PROJECT MAUI - ONCOLOGY

WARRINGAH ROAD & WAKEHURST PARKWAY, FRENCHS FOREST

SCHEDULE OF CHANGES	DEVELOPMENT APPLICATION Rev Revision Description Date
00. Change in layout and heights of	A Section 4.55 Update 23.06.202 B For Section 4.55 application 30.06.202
plant and mechanical overruns. External louvre screening updated to suit.

Maui - Healthcare Warringah Road & Wakehurst Parkway, Frenchs Forest, NSW Section 4.55 Modification

Planting Plan

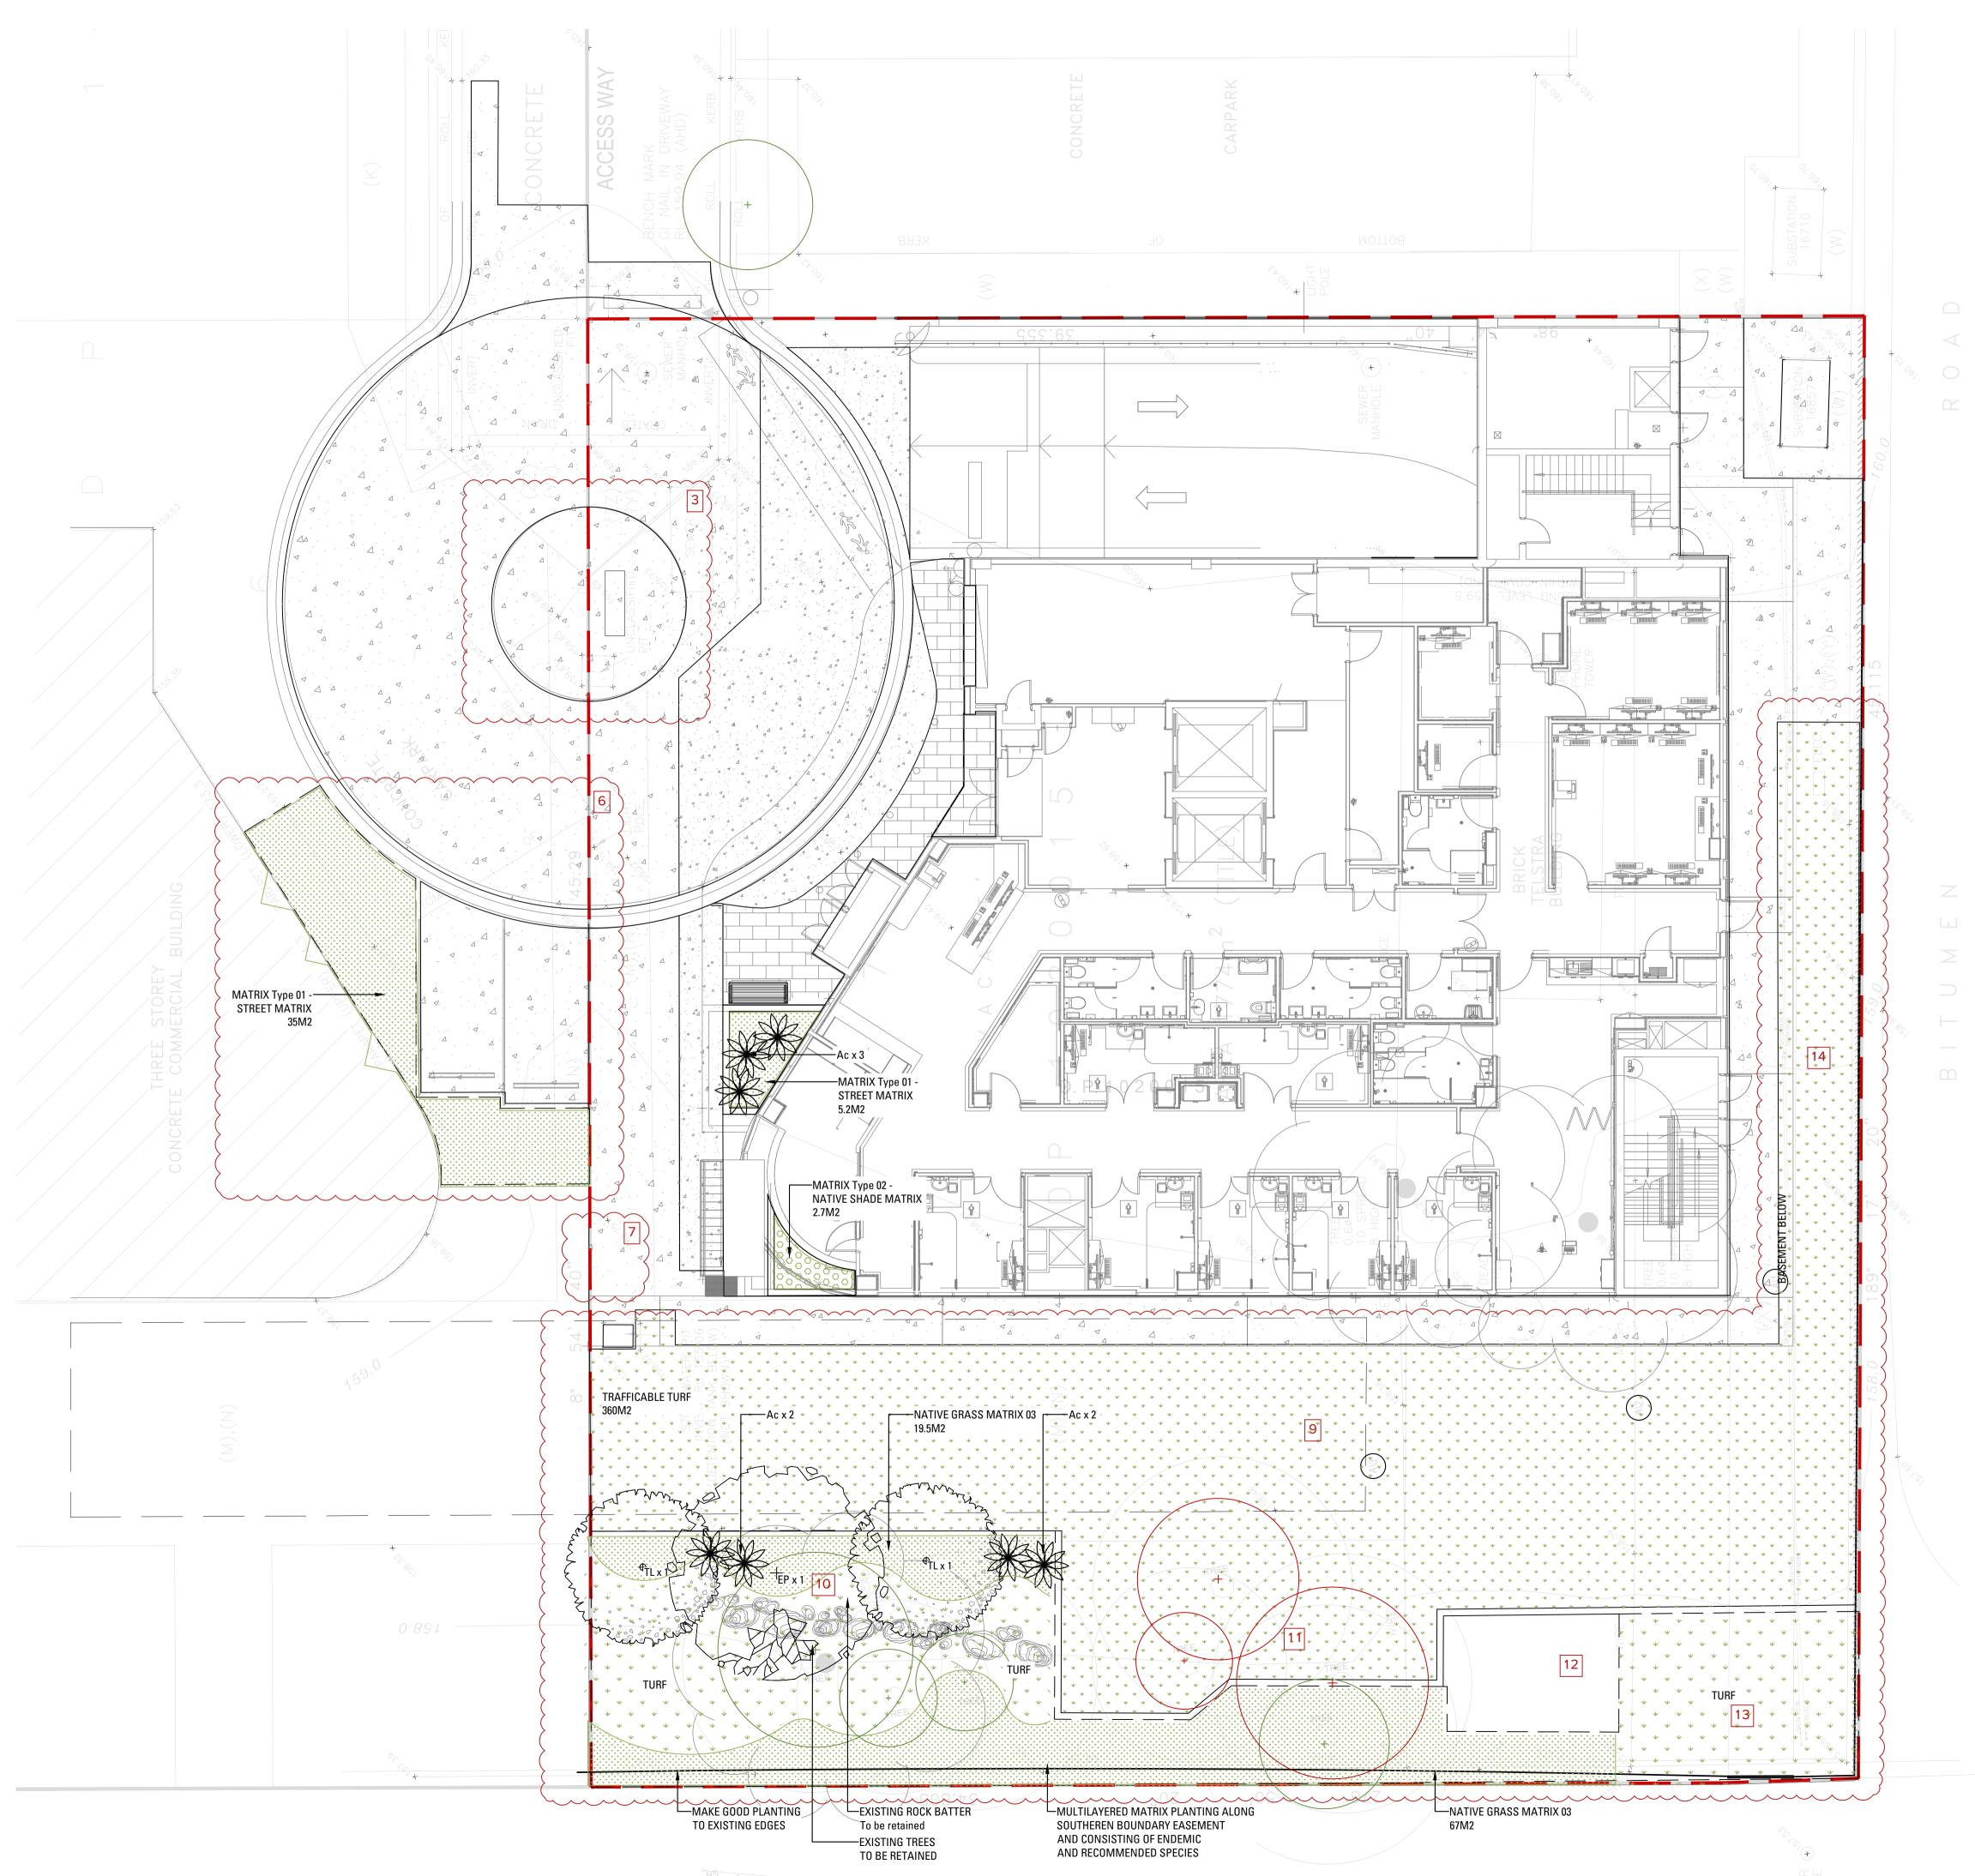
SCHEDULE OF CHANGES: 3: Planting removed to provide required access. 6: Landscape treatment to edges added. 7: Path width revised to provide required access. Planting removed. 9: Planting removed and replaced with trafficable turf. 10. Tree and understory planting revised due to access constraints. 11. Existing trees to be removed due to access constraints. 12: Planting removed and substation added.
13: Emergency access added.
14: Planting removed and replaced with trafficable turf along Eastern boundary.

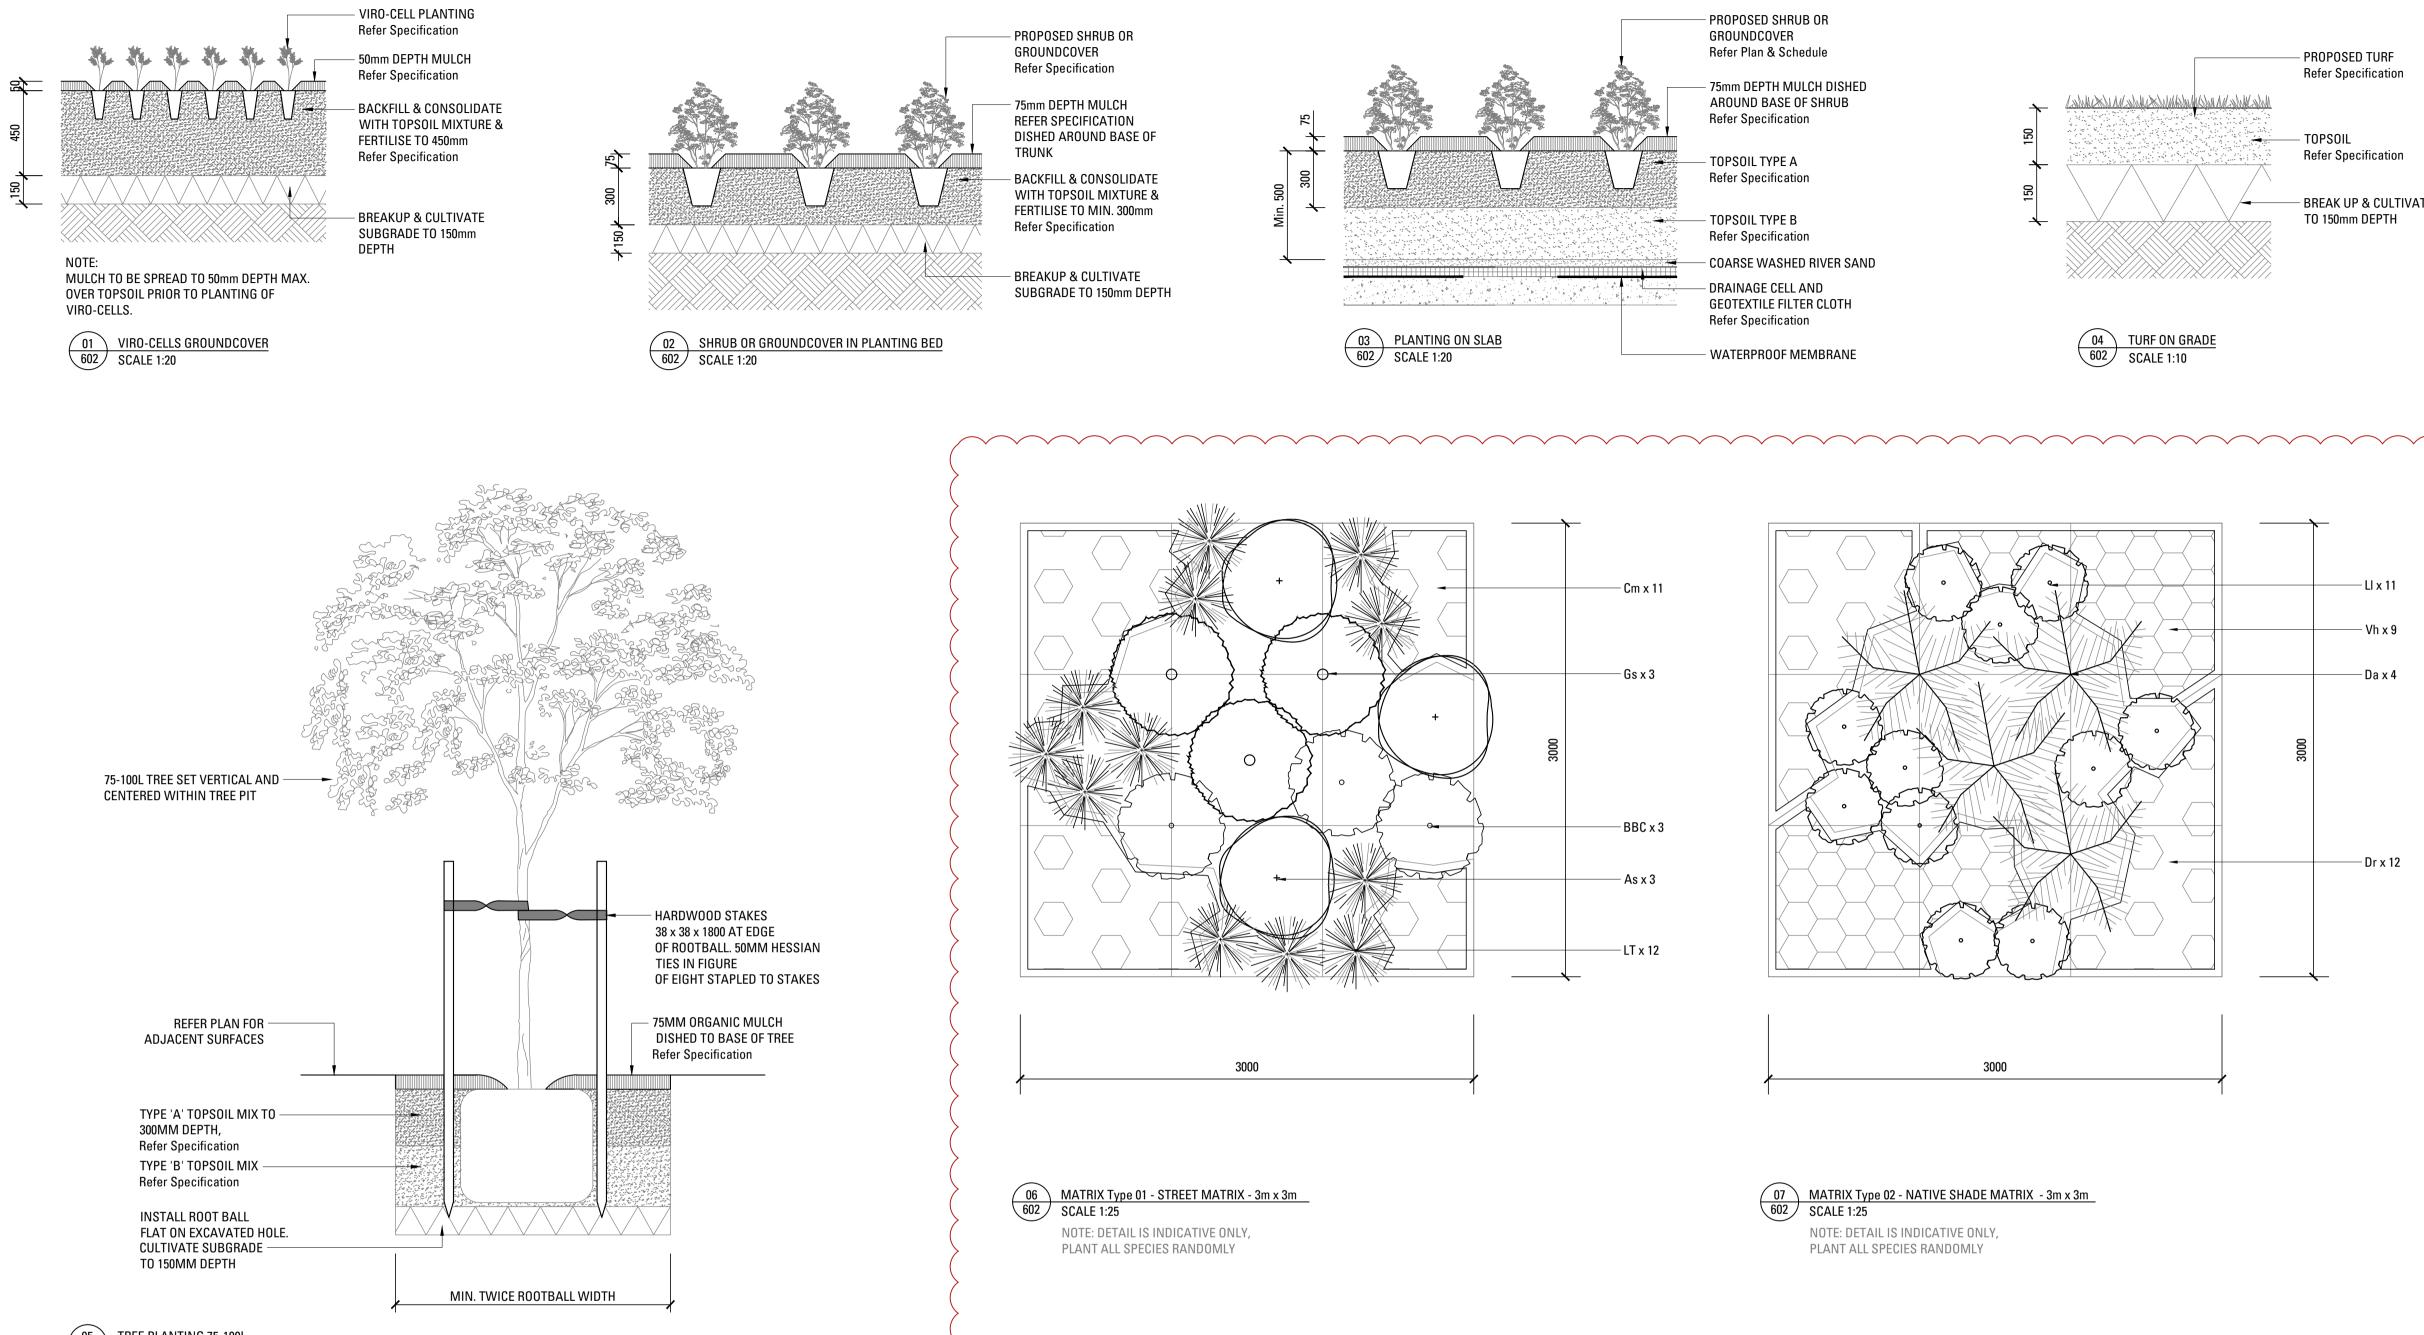
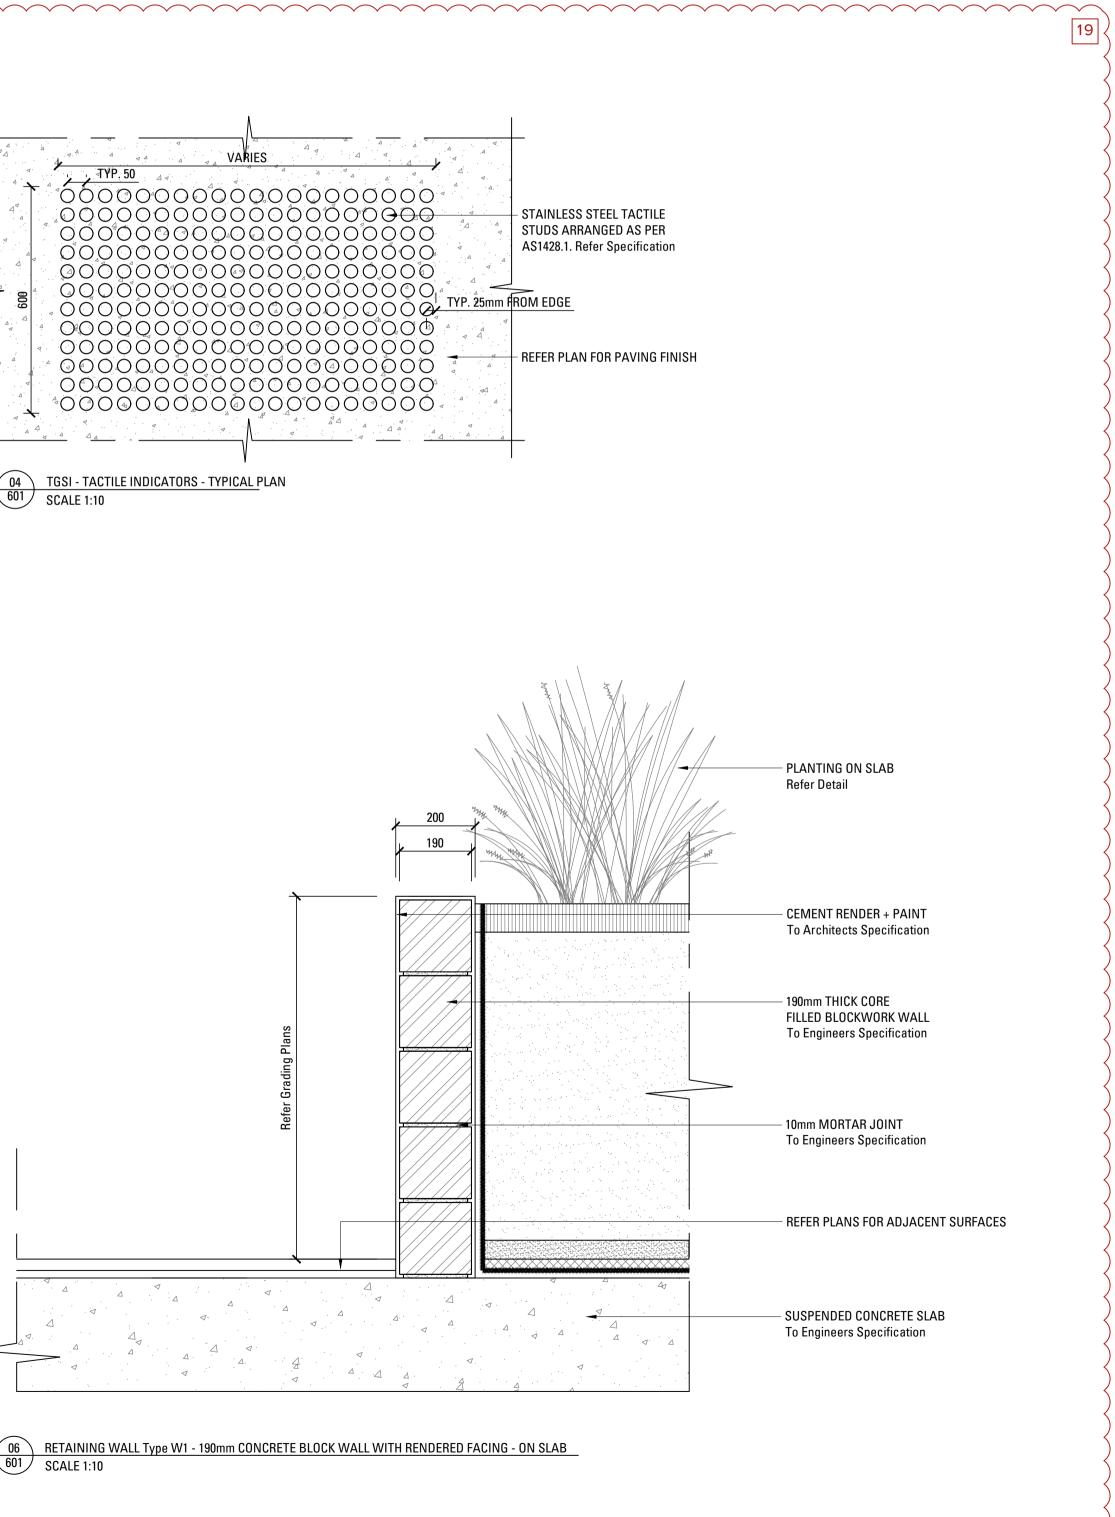
SCHEDULE OF CHANGES: 19: Details added.

Client	Genesis Care 11/ 41-43 Bourke Rd, Alexandria, NSW, 2015 (02) 8236 3300
Architect	Team 2 701/1 Chandos Street, St Leonards, NSW, 206 (02) 9437 3166
Drawing No.	Drawing Name
L-602	Landscape Softworks Details
Job No.	19-635

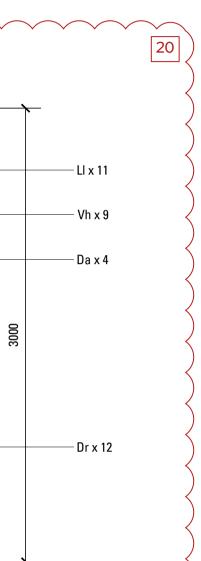
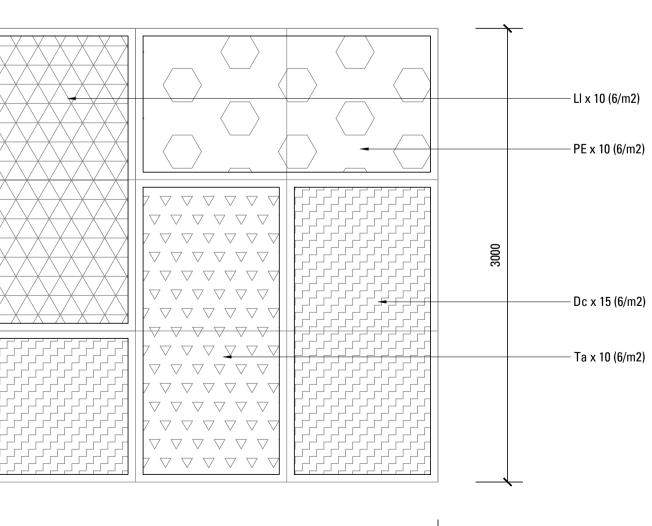
SCHEDULE OF CHANGES: 20: Detail scale changed.

Section 4.55 ModificationClientGenesis Care
11/41-43 Bourke Rd, Alexandria, NSW, 2015
(02) 8236 3300ArchitectTeam 2
701/1 Chandos Street, St Leonards, NSW, 2065
(02) 9437 3166Drawing No.Drawing NameL-0000Cover Sheet

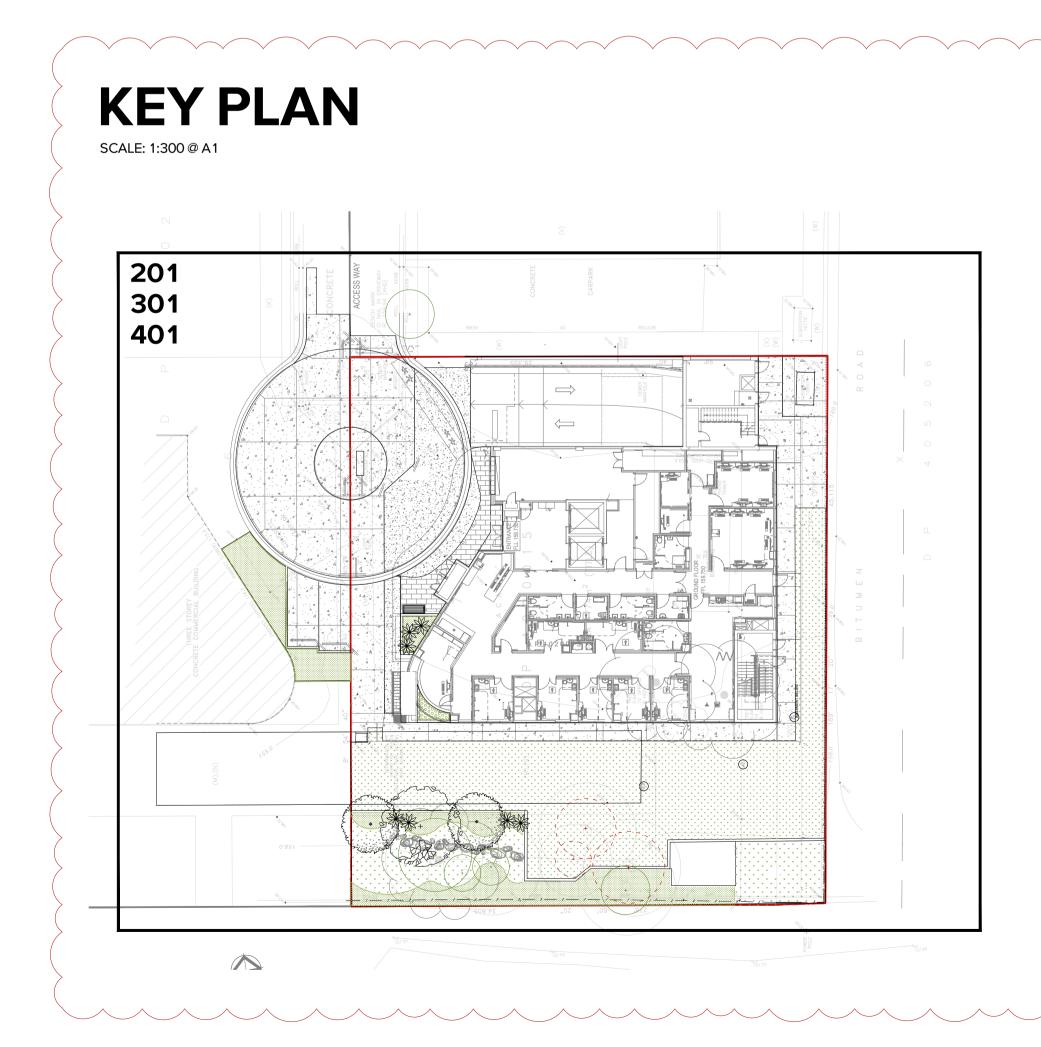
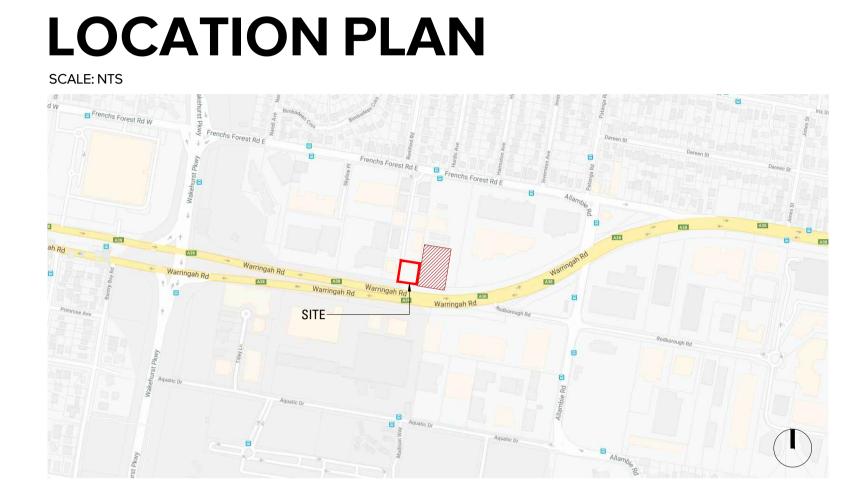
SCHEDULE OF CHANGES: 1: Drawing schedule updated. 2: Key plan added.
